**Proposed Action Memorandum
Seep Collection and Treatment
Operable Unit 7
Present Landfill (IHSS 114) and
Inactive Hazardous Waste
Storage Area (IHSS 203)
Final Report**

December 1994

**Responses to Comments from CDPHE and EPA
Draft Seep Collection and Treatment
Proposed Action Memorandum
Operable Unit No. 7**

Figure 3-2

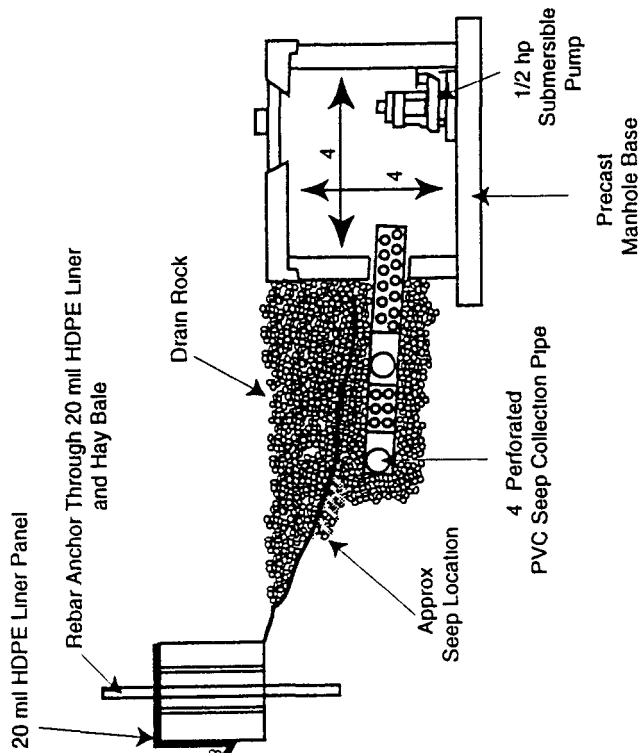
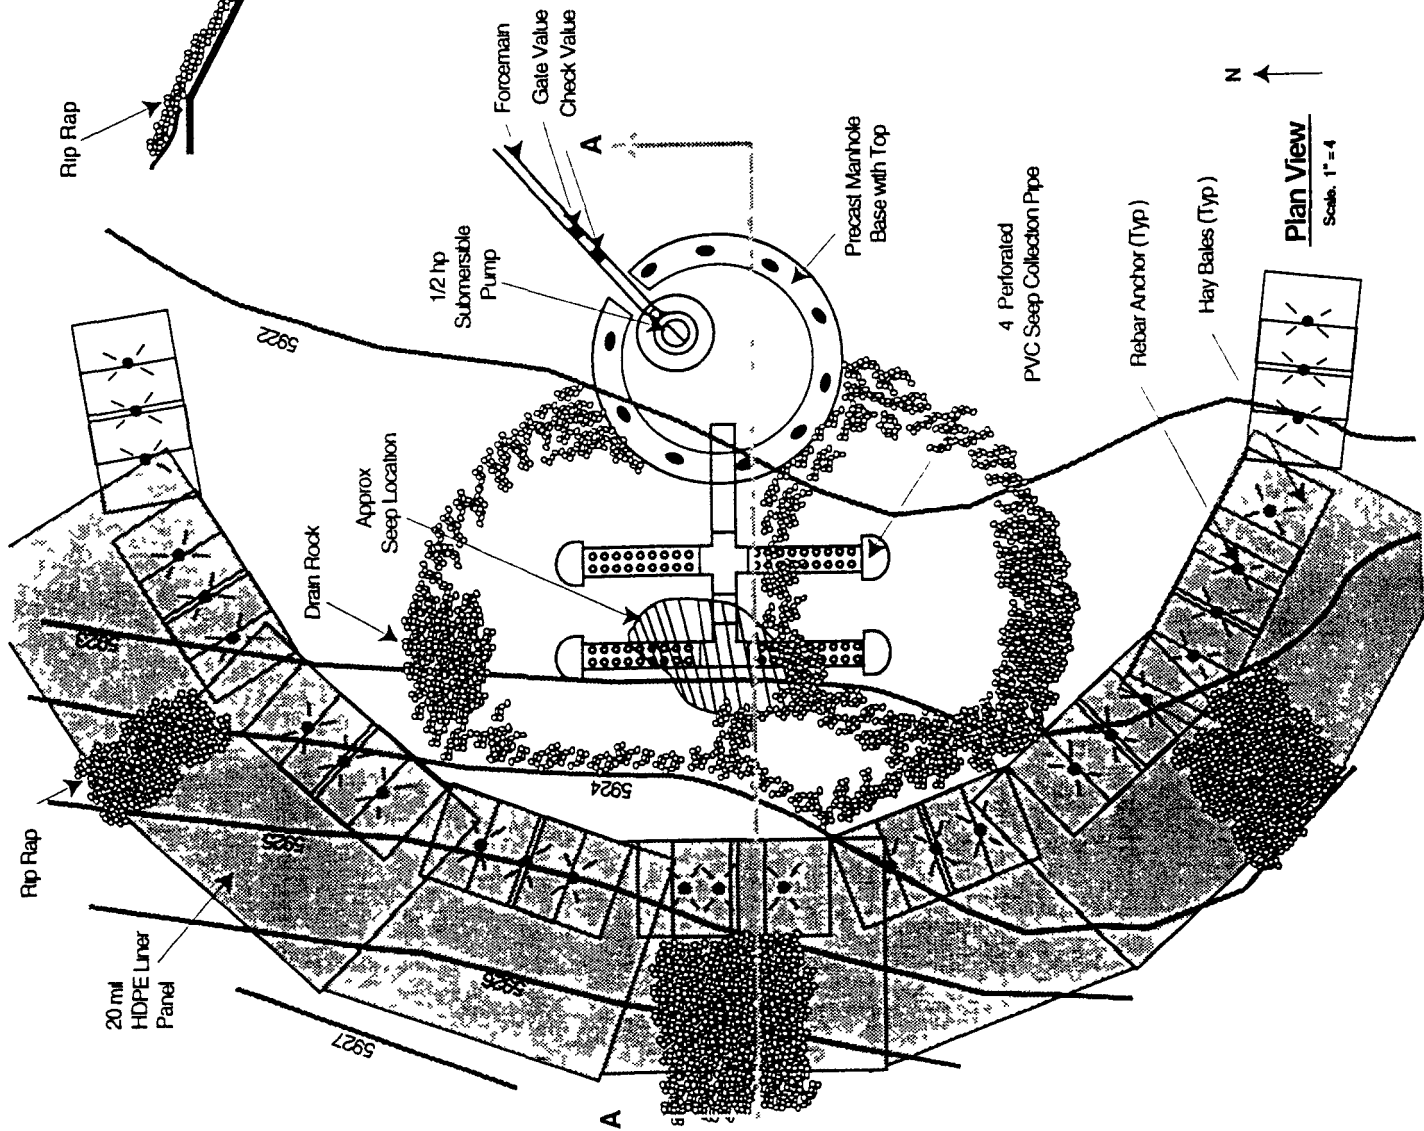
The seep water should be double contained from the time it leaves the sump pump. This would require the 2-inch piping which delivers the water up to the tanks to be double-walled rather than single walled.

The high-level alarm/pump shutoff should be positioned so that it will activate when there is 2 feet of freeboard remaining in the tanks.

Has spill/drip containment at the tanks been planned?

The design will have double-walled piping rather than the single-walled piping from the collection box to the tanks.

The high-level alarm/pump shutoff is positioned with 1 to 1.5 feet of freeboard remaining in the tanks. This provides an additional volume of 1,000 gallons to 1,700 gallons.

The standard operating procedure for pumping and transporting the water will have specific directions to place an inflatable HDPE bath or container beneath the disconnect port to catch any drips. The tanks and all piping to the disconnect port are double-contained for spill control.
